Project Title: EAST CENTURY GATEWAY PLAZA	Building Permit #:	City Drainage #: K20-D061
DRB#: EPC#:		Work Order#:
Legal Description: LOTS 1-3 EAST CENTURY GATEWAY PLAZA		
City Address: 10201 CENTRAL NE		
		Contact: DAVID SOULE
Engineering Firm: RIO GRANDE ENGINEERING		
Address: PO BOX 93924, ALBUQUERQUE, NM 87199 Phone#: 505.321.9099 Fax#: 505.8	72.0999	E-mail: DAVID@RIOGRANDEENGINEERING.COM
Phone#: 505.321.9099 Fax#: 505.8		
Owner: TEKIN PROPERTIES		Contact:
Address: 8036 OAK POINT DRIVE, FRISCO, TEXAS 75034		,,,,,,,,,,,,,,,,,,,,,,,,,,,,,,,,,,,,,,
Phone#: Fax#:		E-mail:
Architect: PETER BUTTERFIELD		Contact: PETER BUTTERFIELD
Address: Phone#: Fax#:		E-mail:
Phone#:		
Surveyor: SURV-TEK	<u> </u>	Contact: rUSTY hUGG
Address:		
Phone#: 9 Fax#:	,	E-mail:
Contractor:		Contact:
Address:		
Phone#:		E-mail:
	CHECK TVPE OF APPROV	VAL/ACCEPTANCE SOUGHT:
TYPE OF SUBMITTAL:	SIA/FINANCIAL GUARAN	
DRAINAGE REPORT	PRELIMINARY PLAT API

RE: East Century Gateway Plaza
Grading and Drainage Plan
Engineers Stamp Date 6/11/14 (K20-D061)

RE: Drainage Resubmittal

Re: Tracts 1 & 3 East Central Gateway Plaza, 10201 Central Avenue NE, Traffic Circulation Layout

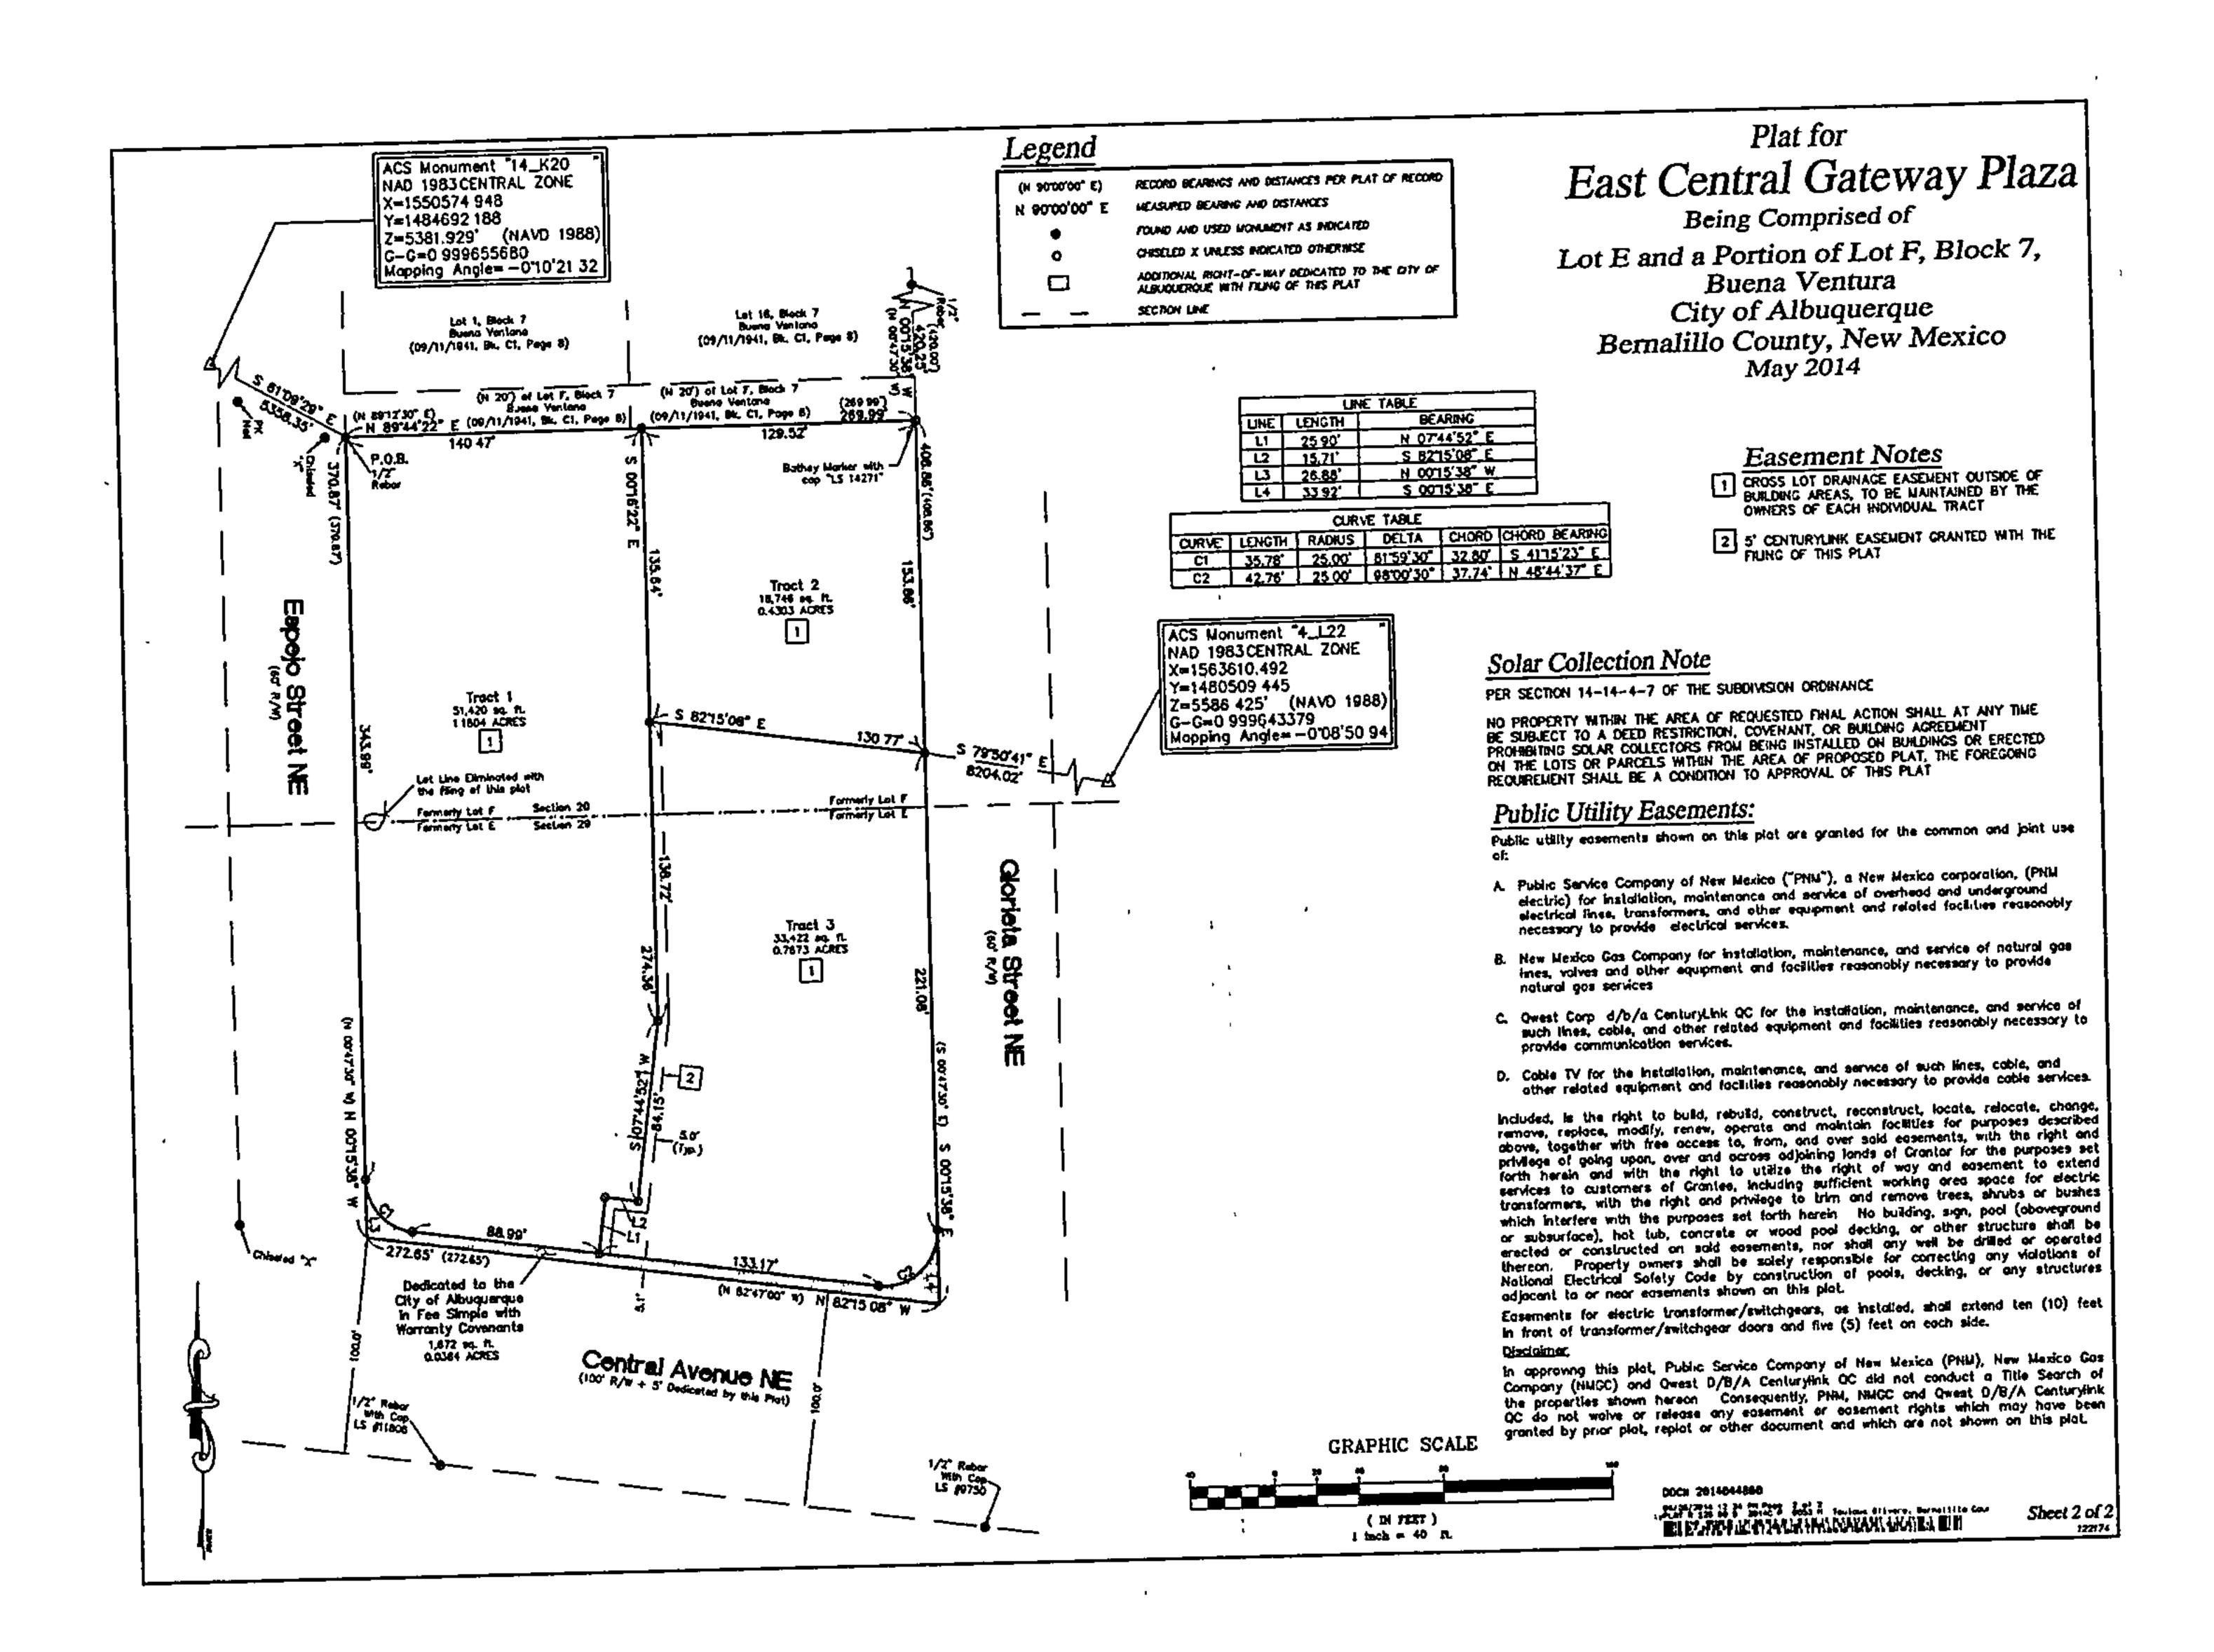
Based upon the information provided in your submittal received 6/11/2014, the above referenced Grading and Drainage Plan cannot be approved for Grading Permit or Building permit until the following comments are addressed.

- A drain with a grease trap needs to be placed in the trash enclosure.
- Add two foot curb cuts spaced every 20 feet in the drive thru lane.

The purpose of this letter is to accompany the revised plan. The plan has been revised to address your written comments dated June 19, 2014. The following is a summary of your comments and he corrections we have done to address.

- 1. A drain from grease trap must be placed in trash enclosure.

Added a note to the plan stating this requirement. I have included a reduced copy of the master utility plan to show we will be constructing this feature
- 2. Add two foot curb cuts at drive thru lane.

We have added two additional curb cuts to the drive thru lane. The lane was designed to have a 1% slope to a single opening, the additional cuts improve the design
